TOWN OF PLAINFIELD PLAN COMMISSION REPORT

CASE NO.: [DP-21-076](#)

PETITIONER: American Structurepoint for Browning Investments

REQUESTED ACTIONS: Petition Seeking Architectural and Site Design Approval of a 551,837 square foot speculative distribution building on a 32.84 acre parcel zoned [I-2: Office/Warehouse Distribution](#) including [Development Incentives](#) for Depth of Yard and Orientation of Loading Space.

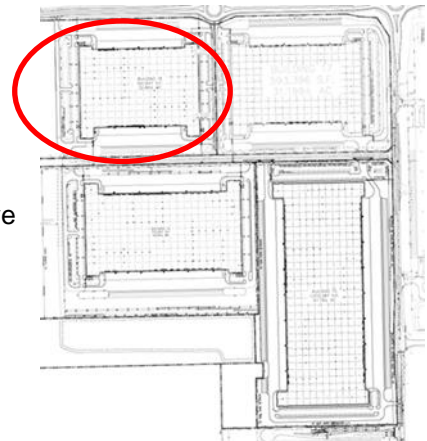
There are two additional buildings in the vicinity that are slated for the Commission's agenda and the Commission recently approved Allpoints 17. The building that is the subject of this staff report is circled in red.
